# CELEBES SEA, EASTERN PORTION—TALAUTSE ISLES.

No. 312 (first publication).—The following particulars, etc., relative to the above, issued by the British Admiralty (No. 1158 of 1921), are republished:—

*Charts affected.*—No. 942*a*, Eastern archipelago—sheet 3.

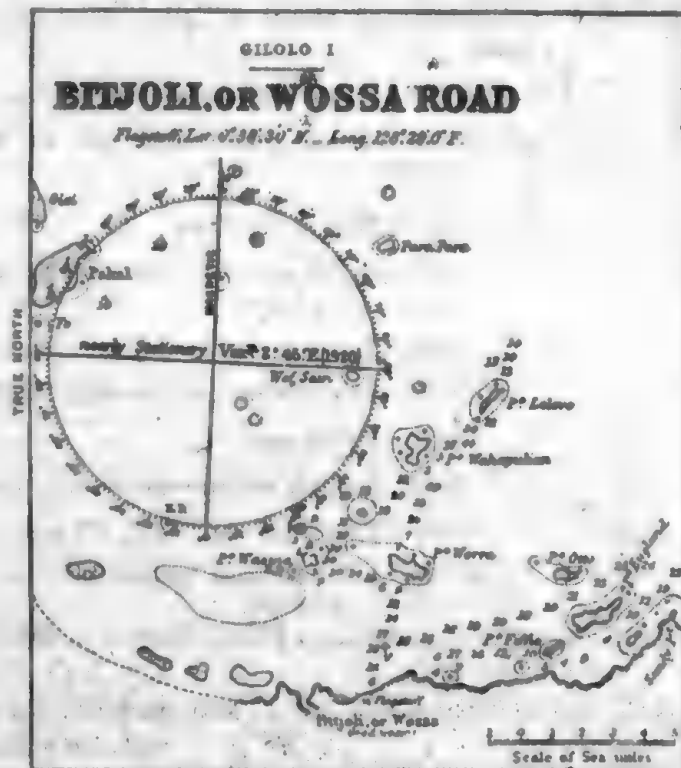
*Details.*—The accompanying reproduction of a portion of chart No. 942*a* and of the plan of Bitjoli or Wossa road on chart No. 930 shows the necessary corrections to those charts with regard to reefs in Wossa bay.

Reproduction of Portion of Chart No. 1017.

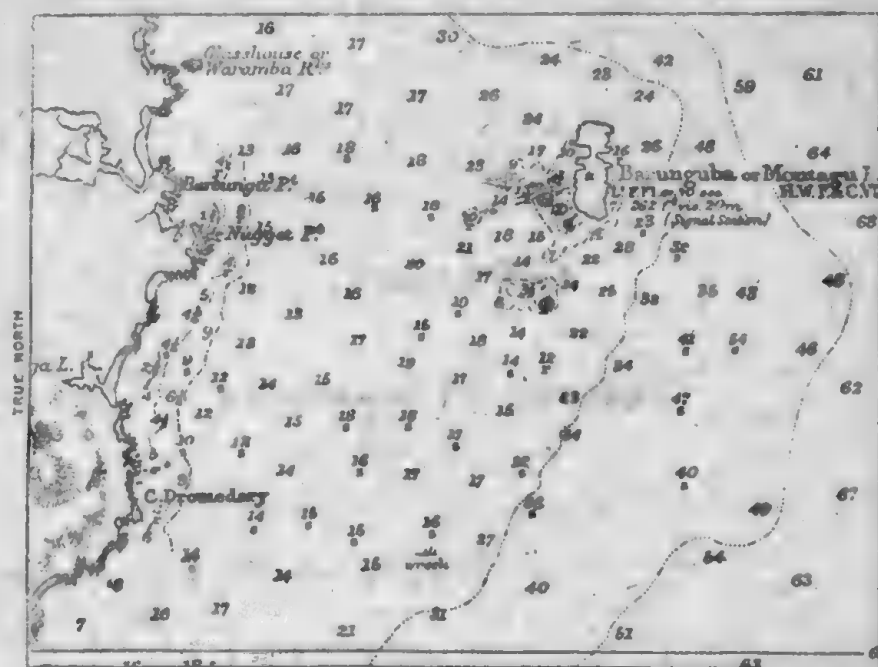
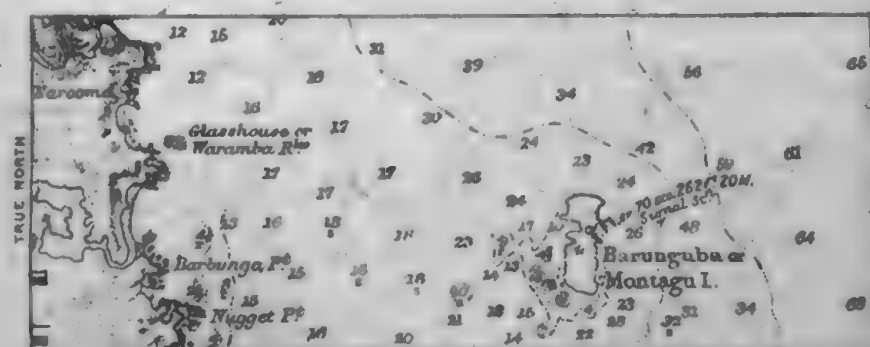
*Remarks.*—It will be seen from the reproduction that no trace was found of the 2½-fathom shoal marked "(P.D.)" south-eastward of Montagu island. This shoal is to be expunged from chart No. 1211.

Reproduction of Portions of Chart No 651

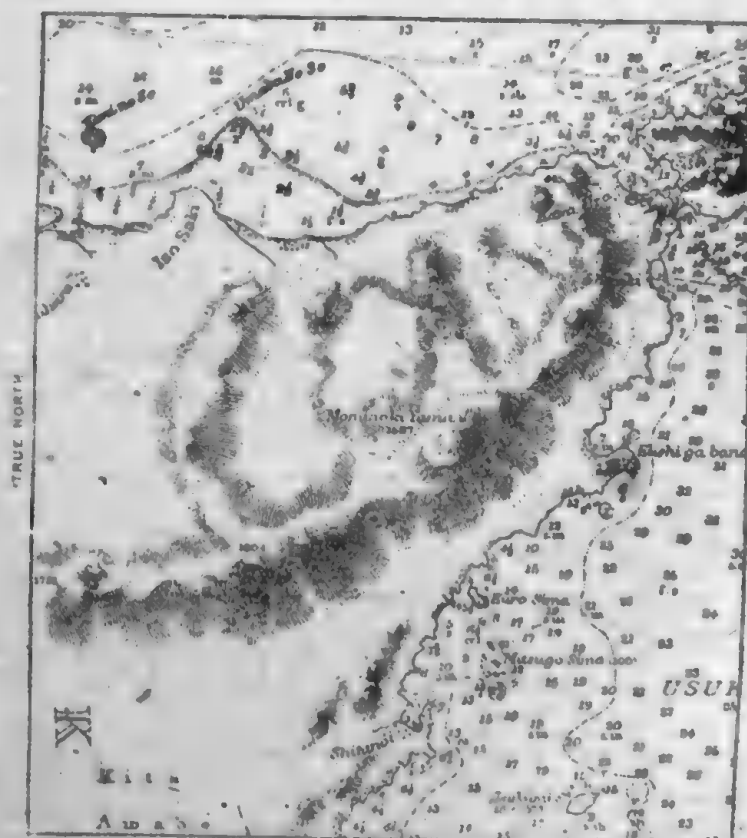
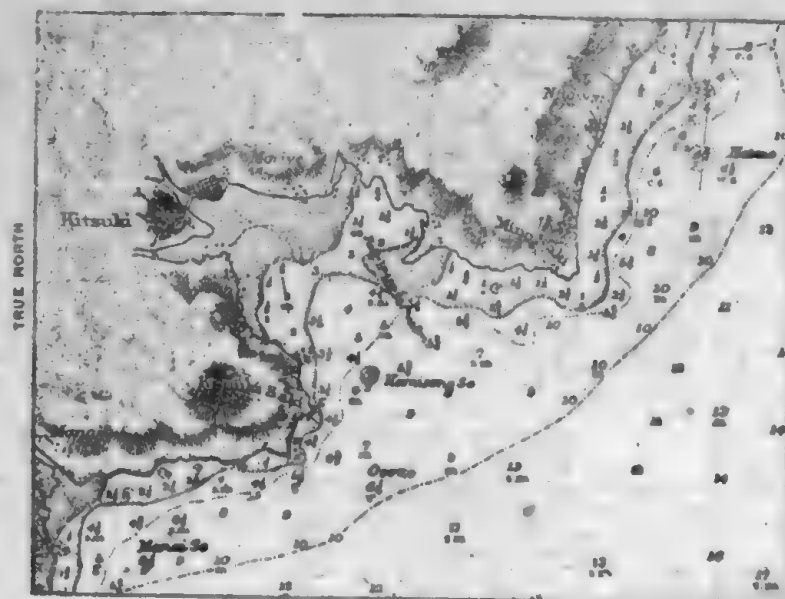
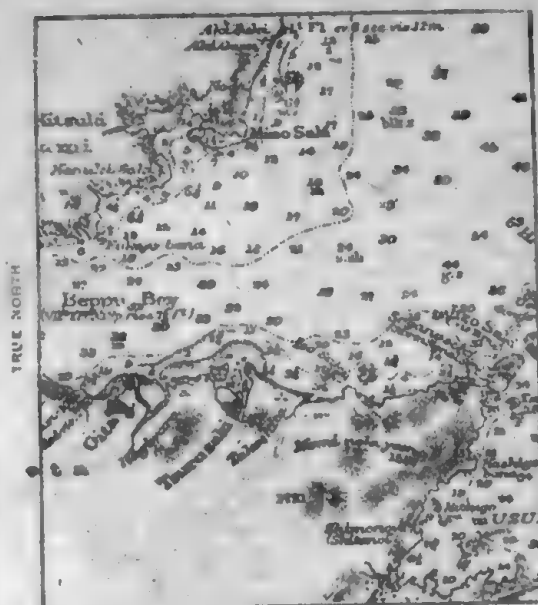
*Details.*—Amendments with regard to shoals in Beppu and Usuki bays are shown on the accompanying reproductions of portions of charts Nos. 651, 2875 and 1648.

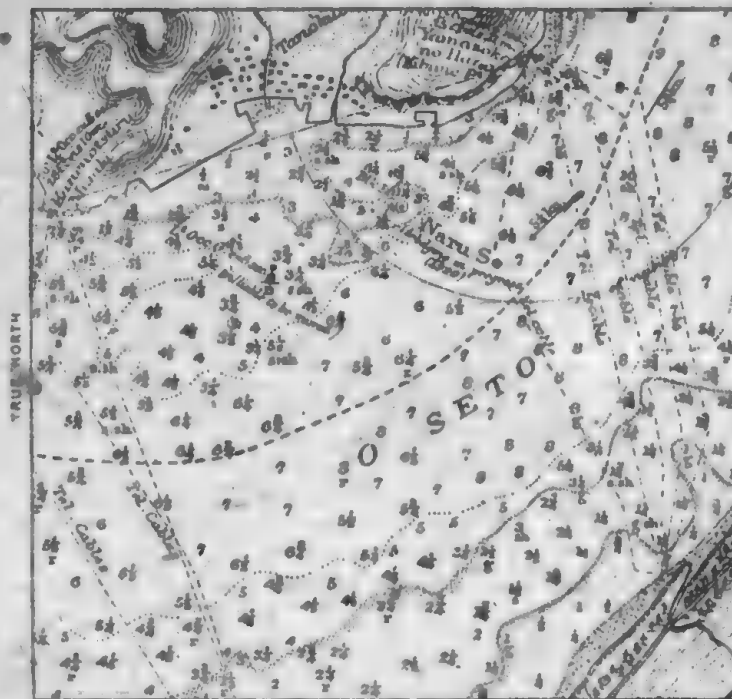
*Details.*—The accompanying reproduction of portions of charts No. 1578 and 532 shows the necessary corrections to those charts with regard to new positions of telegraph cables across *O seto*.

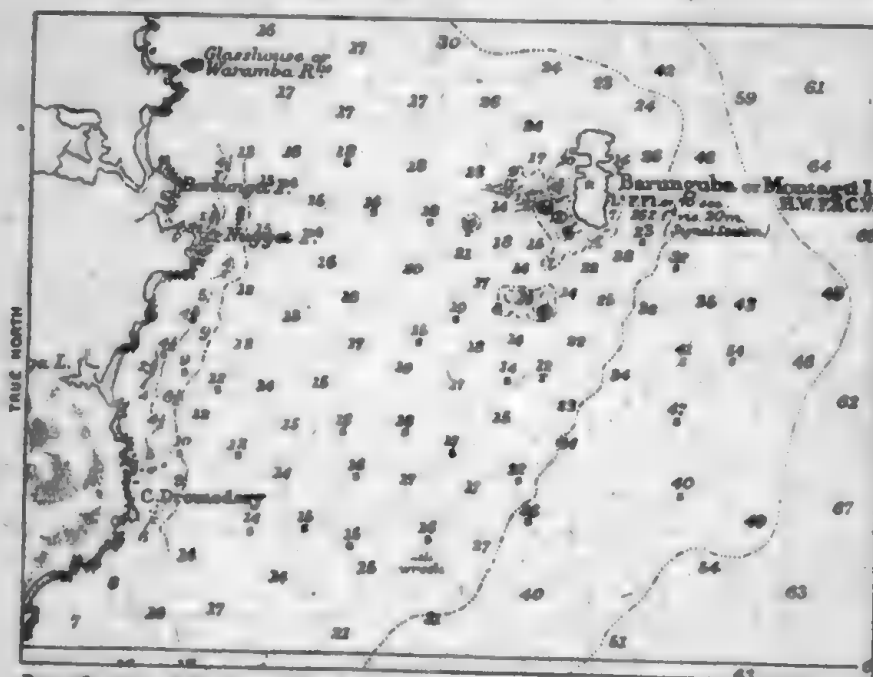
*Details.*—The accompanying reproduction of portions of charts Nos. 1017 and 1018 shows the necessary corrections to those charts with regard to the coastline of Montagu island, and the rocks and depths in the vicinity, as revealed by a recent survey.

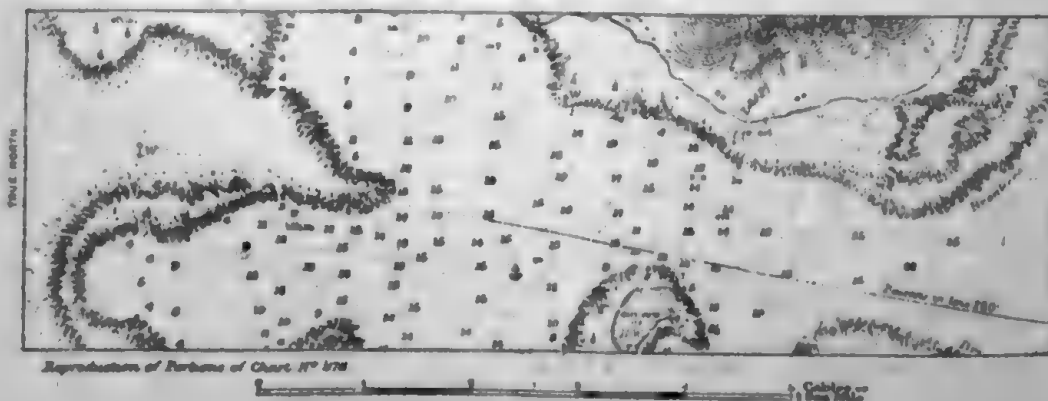
*Details.*—The accompanying reproduction of portions of chart No. 978 and the inset plan of Chabrol harbour shows the necessary corrections to that chart with regard to the positions of beacons.
